MEMORANDUM

Subject: CUP21-0006 Conditional Use Permit Request for Townhomes on the Ground Floor in the GC General Commercial Zoning District on 8.444 acres at 203 Country Club Drive SW (Tax Parcel No. 287-A 41A) by Steve Semones of Balzer and Associates, Inc. (applicant) for Diversified Investors XIII, LLC (property owner).

# Rugby Field Townhomes CUP 21-0006

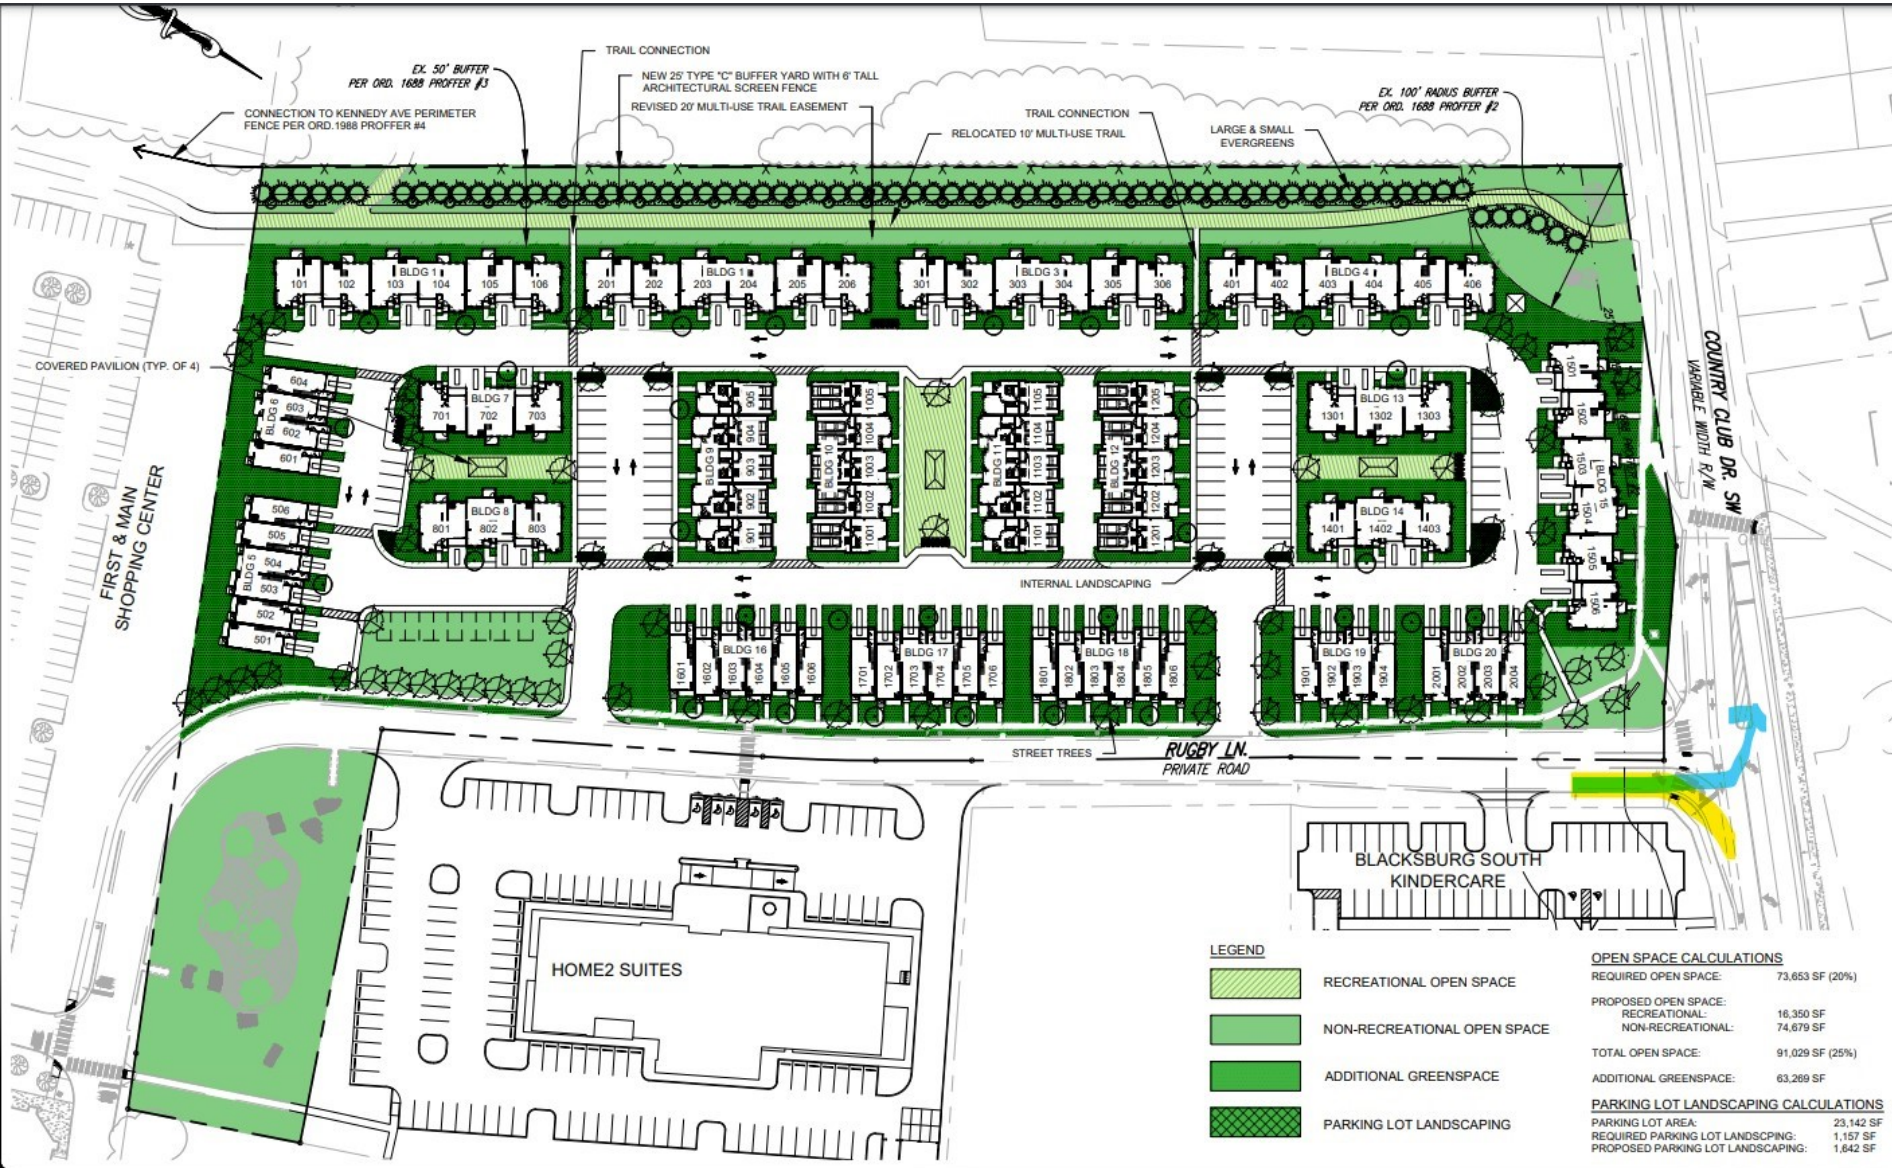
My child attends Kindercare so I am very familiar with this area. My concern is traffic impact. Exiting Ruddy Lane, the future residents may leave through the First and Main shopping center or by a right hand turn only onto County Club Drive. First, I am curious if a traffic study has been conducted to better identify the impact by the applicant. Second, I would like to suggest two scenarios:

- option 1 - extend the right hand only turn obstructions (concrete barrier or permanent yellow stakes) further down the road so someone could not safely turn left. At this time, it barely directs you to the right so is quite easy to turn left with full visibility.
- option 2 - propose a round-a-bout

The desire to turn left from this location will only increase with residences here.  
The frequency of illegal left hand turns is already a daily occurrence.
